North Central Texas
Council of Governments

Recommended Amendments to the 2021 International Plumbing Code

Recommended Amendments to the 2021 International Mechanical Code

Recommended Amendments to the 2021 International Fuel Gas Code

ADD: Figure: 25 TAC §265.186 (e) (6)

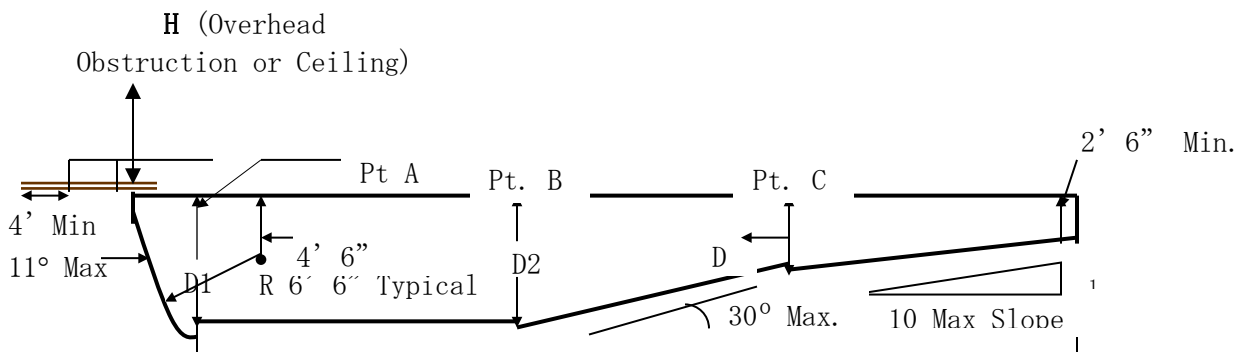
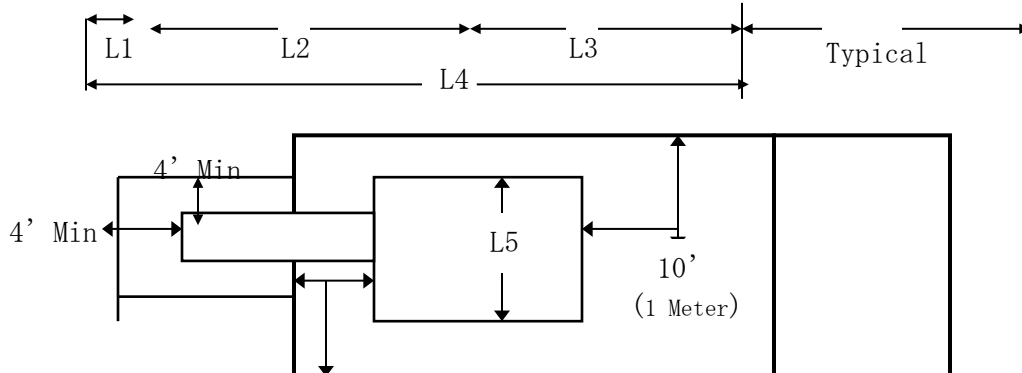
402.12 Water envelopes. The minimum diving water envelopes shall be in accordance with ~~Table 402.12~~ **Texas department of State Health services, Administrative Code Title 25, Chapter 265, Section 186 (e) and Figure: 25 TAC 256.186 (e) (6).** (Delete Table 402.12 and Figure 402.12)

Maximum Diving Board Height Over Water	¾ Meter	1 Meter	3 Meters
Max. Diving Board Length	12 ft.	16 ft.	16 ft.
Minimum Diving Board Overhang	2 ft. 6 in.	5 ft.	5 ft.
D1 Minimum	8 ft. 6 in.	11 ft. 2 in.	12 ft. 2 in.
D2 Minimum	9 ft.	10 ft. 10 in.	11 ft. 10 in.
D3 Minimum	4 ft.	6 ft.	6 ft.
L1 Minimum	4 ft.	5 ft.	5 ft.
L2 Minimum	12 ft.	16 ft. 5 in.	19 ft. 9 in.
L3 Minimum	14 ft. 10 in.	13 ft. 2 in.	13 ft. 11 in.
L4 Minimum	30 ft. 10 in.	34 ft. 7 in.	38 ft. 8 in.
L5 Minimum	8 ft.	10 ft.	13 ft.
H Minimum	16 ft.	16 ft.	16 ft.
From Plummet to Pool Wall at Side	9 ft.	10 ft.	11 ft. 6 in.
From Plummet to Adjacent Plummet	10 ft.	10 ft.	10 ft.

(Reason: To avoid conflict with 25 TAC Chapter 265.)
